SERVICE INFORMATION LETTER NO. SI40NG-065/2

SUPERSEDES SERVICE INFORMATION LETTER SI40NG-065-1

All DA 40NG aircraft

Air Intake System Hose
ATA-Code: 71-60

Figure 1: Left - SCEET Hose, Right - Current DAI Part

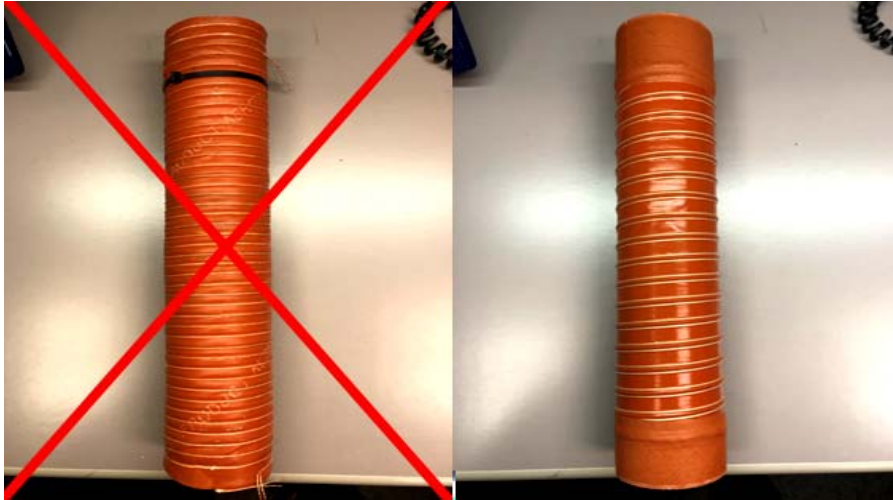
- 1.4.1 As shown in Figure 1 below, the SCEET hose can be identified by the “Aeroduct Product” stamping (or other reference), single string reinforcement and non-reinforced ends. The DAI part can be identified by the double stitching and in later serial number the reinforced ends.

- 1.4.3 Upon inspection, if you cannot positively identify the hose as a correct DAI part, remove and discard the hose.
- 1.4.4 Install the DAI hose (P/N DS_HA2-75-0340-30-30), chafe protector (P/N D44-7166-00-70) and ensure proper fitting of the hose. For the hose clamp installation, refer to the DA 40NG AMM Chapter 20-70-00.
